Addendum No. 3

Diablo Road Trail and Drainage Improvement Project Project No. C-055

PLAN AND PROFILE STA: 0+00 - 5+00
IMPROVEMENT PLANS FOR DIABLO ROAD TRAIL
TOWN OF DANVILLE, CALIFORNIA

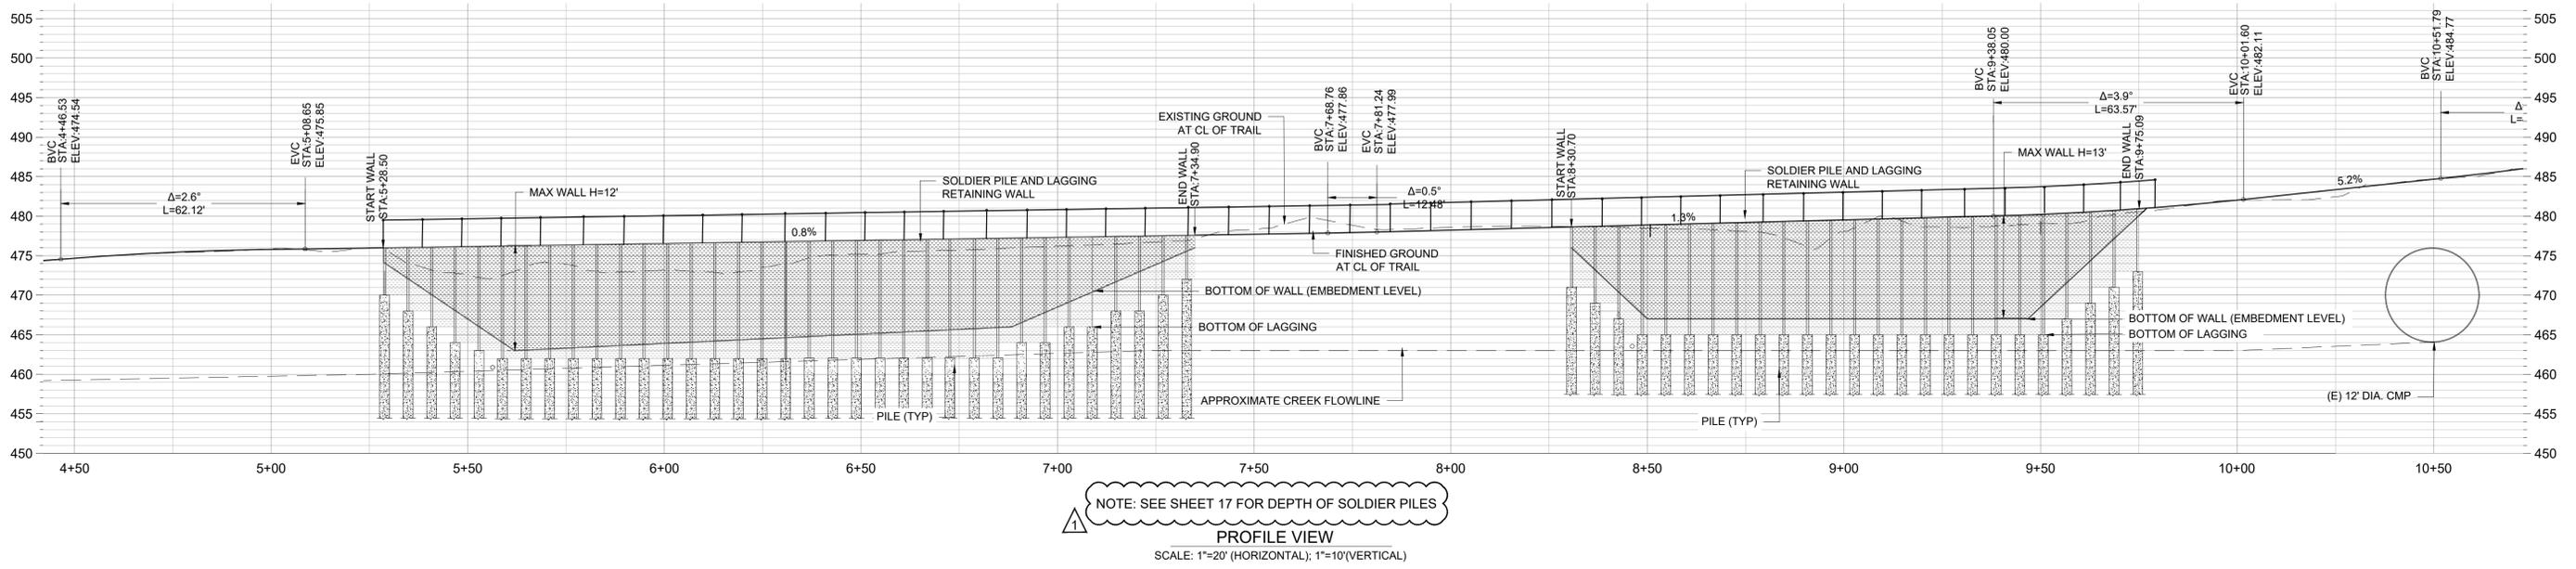
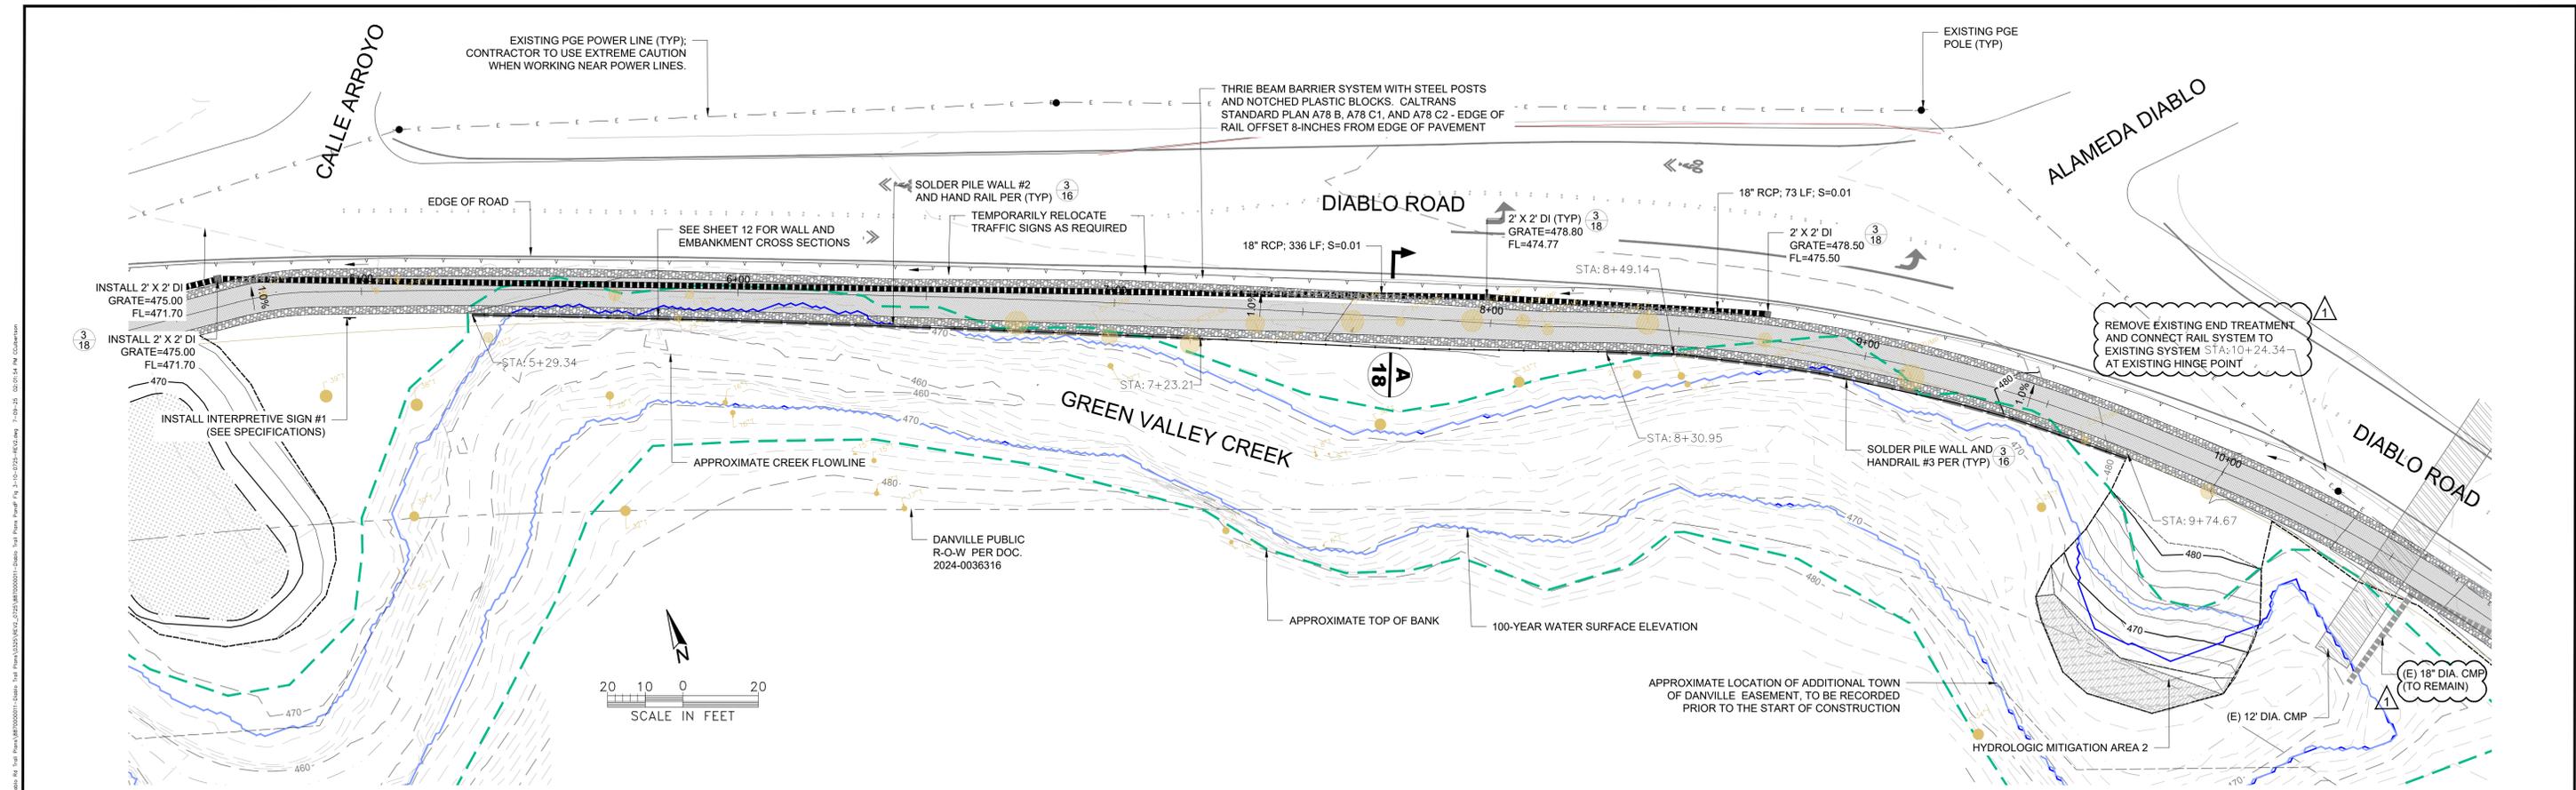
54- There are several rock check dams shown on plan sheet 3, how do they get paid.

76- Plan Sheet 3 shows 3 each 2'x2' rock check dams to be installed. There is no bid item for this work, nor does the measurement and payment for Bid Item 21 address these check dams. Please confirm these check dams are to be measured and paid for under Bid Item 21, or please provide a bid item for this work to be performed under.

77- Plan Sheet 3 shows 12" RCP to be installed and Plan Sheets 5 & 7 show 12" CMP to be installed. There are no bid items for this work. Please provide a bid item for this work to be performed under.

85- We appear to be missing a Bid Item for the following work: 12-inch Diameter Reinforced Concrete Pipe (two Runs called out on Sheet 3/22). Can the City please add a bid item for this work?

- a. Rock check dams are paid from bid item 21 as added in Addendum 2.

- a. See response to question 54.

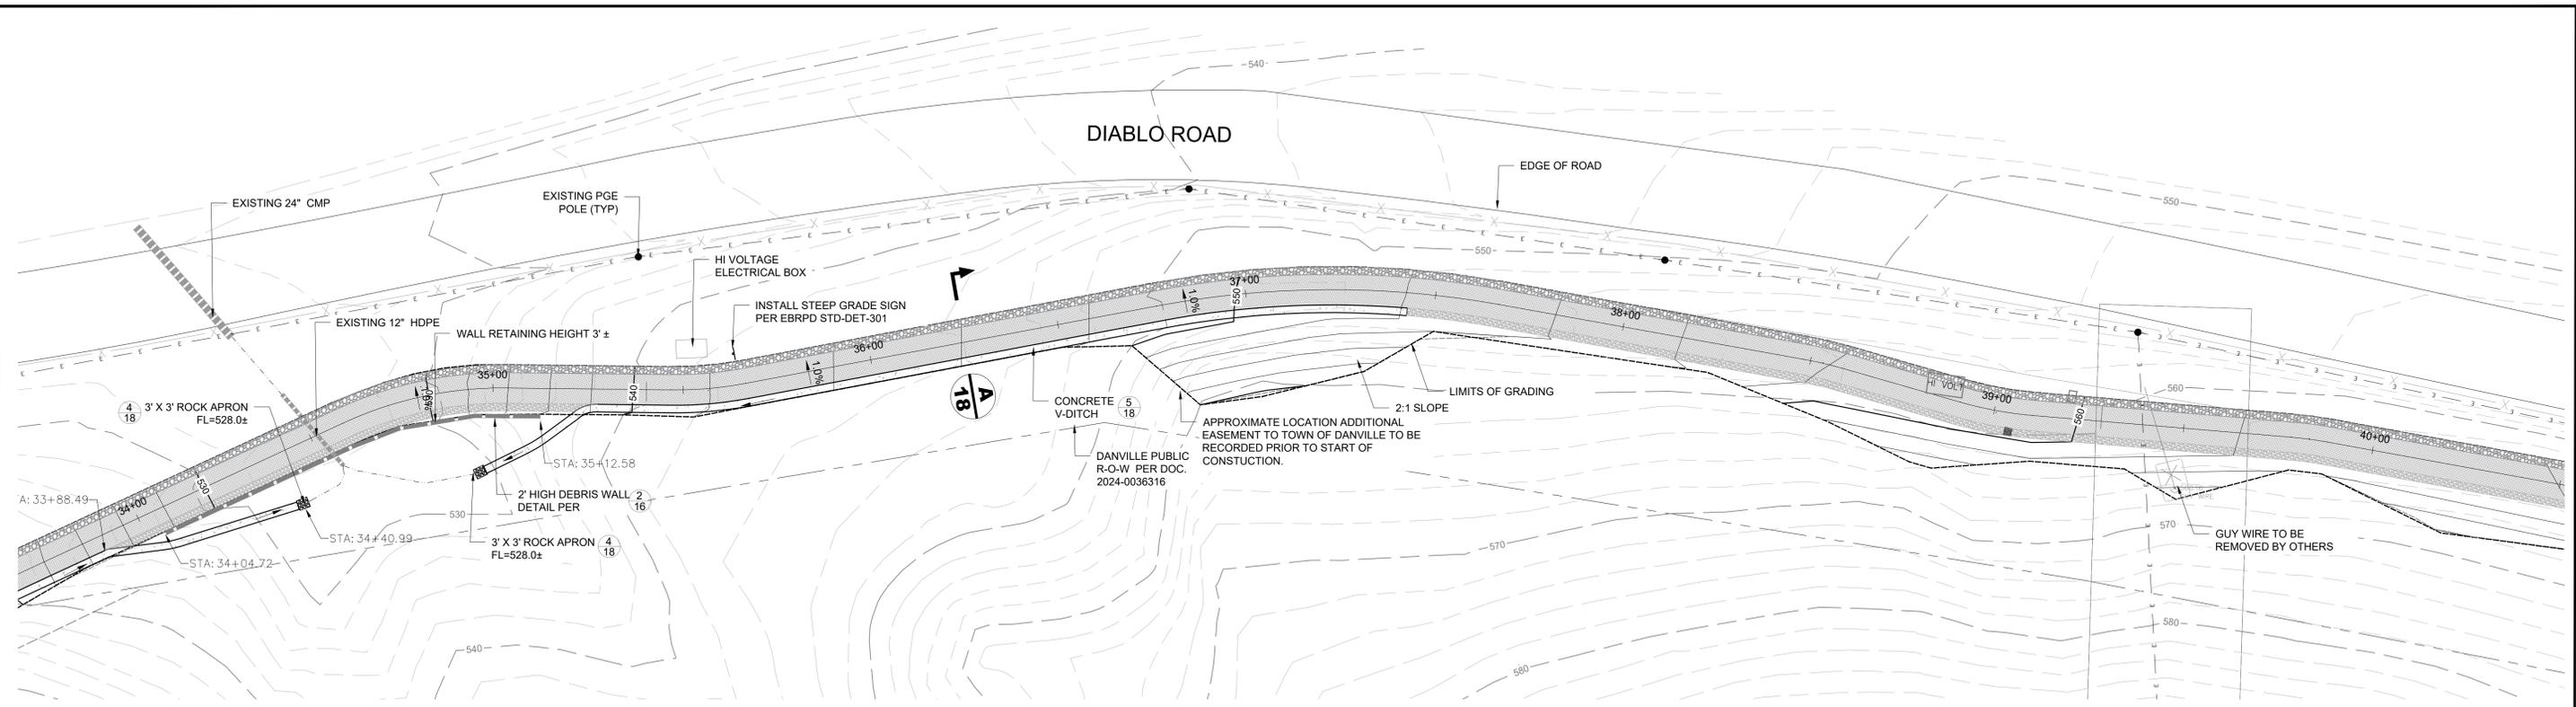
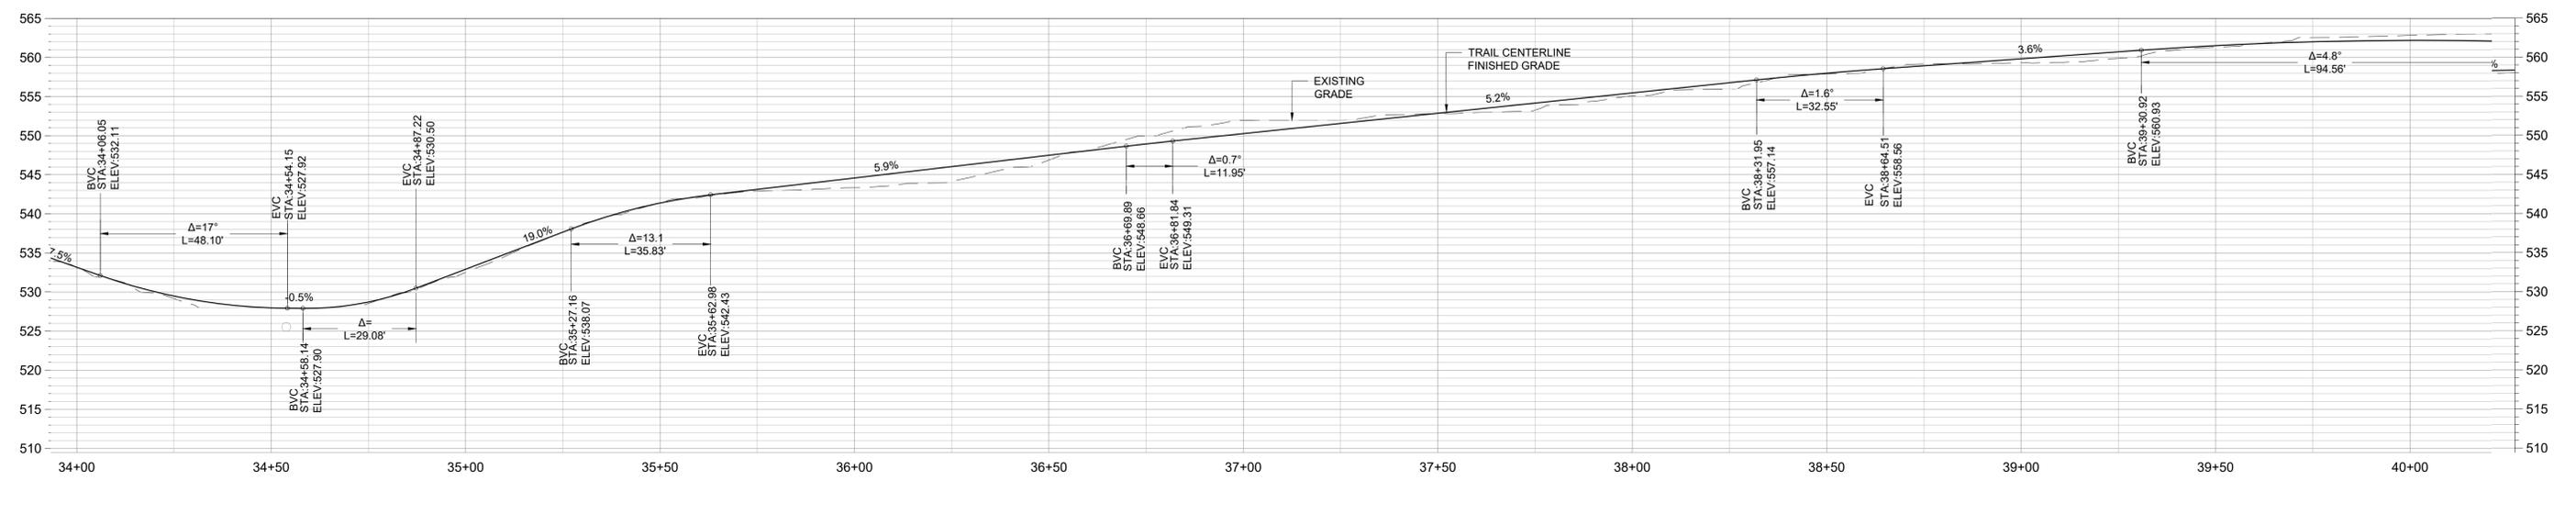
59- There is no profile provided for the MSE wall on Plan Sheet 8 from Sta. 30+35.38 to Sta. 31+53.49. Please provide.

71- On sheet 8 of 22, the plan view shows an MSE wall starting at STA 30+35.38 and ending at STA 31+53.49. However, this wall is not shown in the profile view. Can you confirm whether there is supposed to be an MSE wall at this location? If so, could you please provide profile view and other details?

72- Please provide cross sectional and profile views for the MSE wall shown on plan sheet 8, 30+35.38 to 31+53.49.

- a. The MSE wall on sheet 8 has been modified to be a Debris Wall in Addendum 2 and the quantities of the two other walls have been converted to square feet bid quantities.

- a. See response to question 59.

- a. See response to question 59.

1 TYPICAL SOLDIER PILE WALL DETAIL
NO SCALE

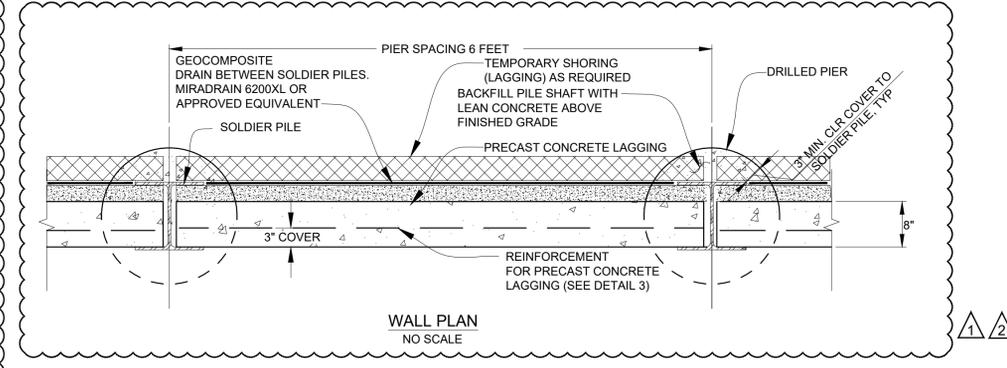
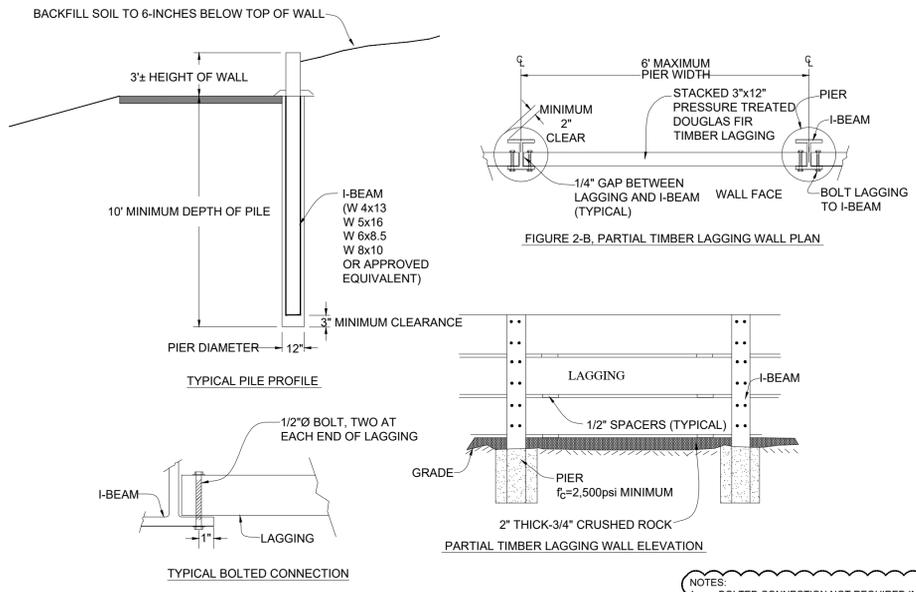
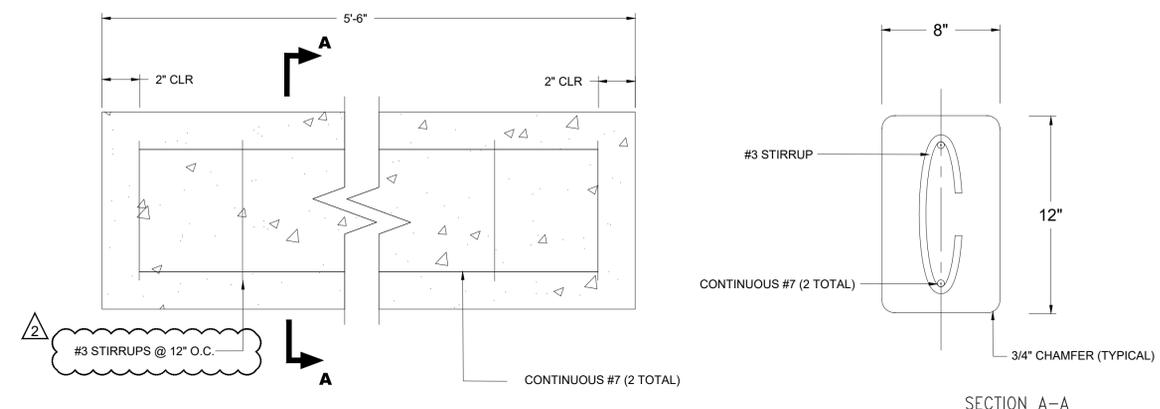
46 - Plan Sheet 16, Detail 1 shows an additional 4 layers of Tensar InterAx NX 650 Geogrid to be installed in addition to the geogrid to be installed under the AB. Do these 4 additional layers get installed along the entire length of the trail, or do they only get installed adjacent to the soldier pile walls? How are these 4 additional layers of geogrid paid?

47 - Plan Sheet 16, Detail 1 shows "TEMPORARY SHORING (LAGGING) AS REQUIRED (BY OTHERS)". This note indicates this would be performed by other forces outside of this contract. Please confirm the Town's intent of this note.

52- Looking at the typical soldier pile wall detail on sheet 16.

- a. We have removed this call out in Addendum 2 from the plans.
